**Remedy Optimization Team Report for the  
Bethpage Groundwater Plume Remedy**

**Prepared By**  
**The Technical Team for Optimization of the Bethpage Plume Remedy**

April 29, 2011

Figure B-1

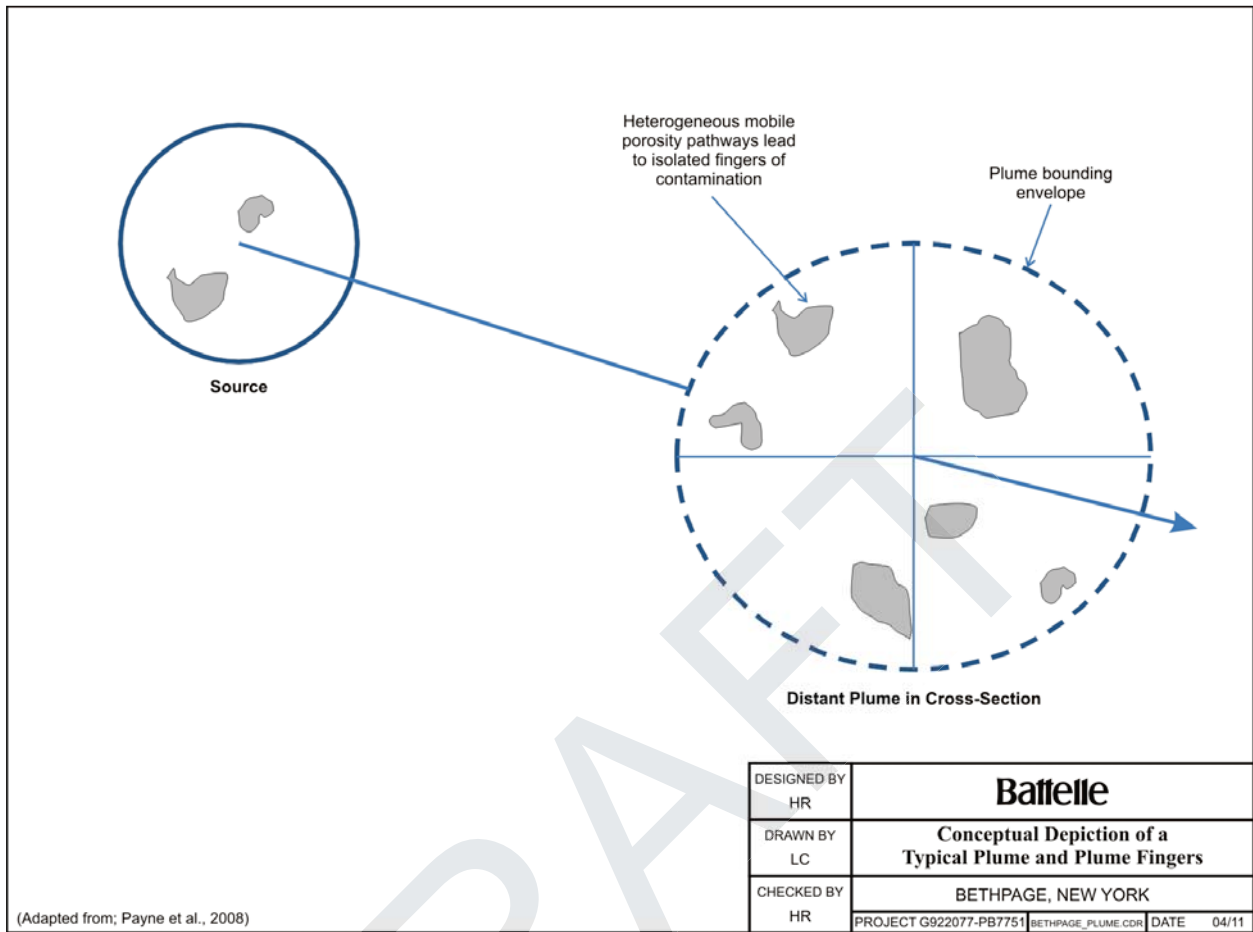
The Technical Team noted that this large and deep plume in a highly complex geologic setting has posed and will continue to pose relatively unique challenges for decision makers. Figure B-1 provides the general site layout at Bethpage such as locations of the Navy's and Northrop Grumman Corporation's former facilities as well as current remedy locations. Although the "Bethpage Plume" is often referred to as a single plume, there are multiple plumes and/or plume fingers due in part to the permeability contrasts resulting from heterogeneous geology involved (see conceptual depiction of a typical plume and plume fingers in attached Figure B-2). The Technical Team noted that the east-west geologic cross-section C-C' is strikingly similar to the dispersed plume concept presented in Figure B-2 (see geologic cross-sections shown in Figures B-3 to B-6). Instead of a single, contiguous plume, there are multiple widely dispersed plumes or fingers. If finer resolution (and adequate plume characterization) were possible, several more fingers might become apparent in these already dispersed plumes. Given the size and depth of the impacted aquifer, there are inherent limitations at this site in adequately delineating and managing the plume. These inherent limitations create uncertainties for any plume monitoring, modeling, or capture efforts, whether in the northern portion near source areas or in the southern portion near the leading edge. These limitations need to be taken into account in planning plume management strategies. Although there are other sites (e.g., Hill Air Force Base or Massachusetts Military Reservation) with relatively large VOC plumes, the unique combination of deep aquifer, large plume, geologic complexities, persistent dense non-aqueous phase liquid (DNAPL), multiple sources, and proximity to public water supply wells makes this site somewhat unique.
